ATTACHMENT FOUR
 PROPOSED TECHNICAL SPECIFICATION REVISIONS
 FOR
 RELAXED AXIAL OFFSET CONTROL (RAOC)

CALLAWAY - UNIT 1

ATTACHMENT FIVE
PRELIMINARY CYCLE 6 COLR CHANGES FOR
RELAXED AXIAL OFFSET CONTROL (RAOC)

FIGURE B 3/4.2-1
TYPICAL INDICATED AXIAL FLUX DIFFERENCE VERSUS THERMAL POWER

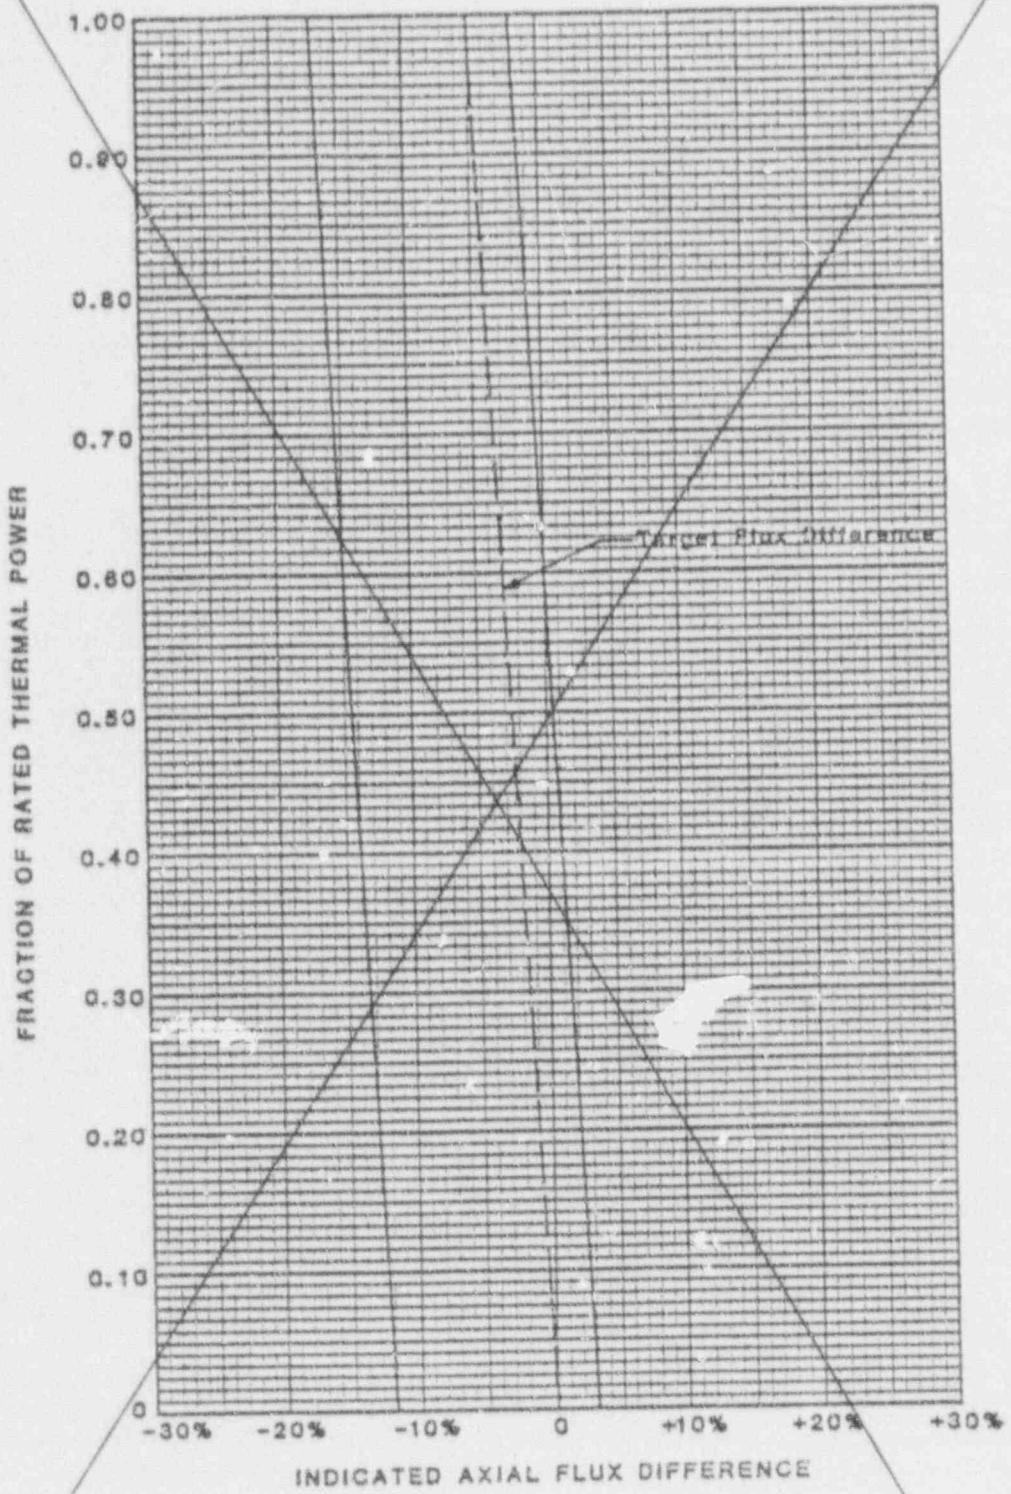
Figure B 3/4.2-1 shows a typical monthly target band.

DELETED
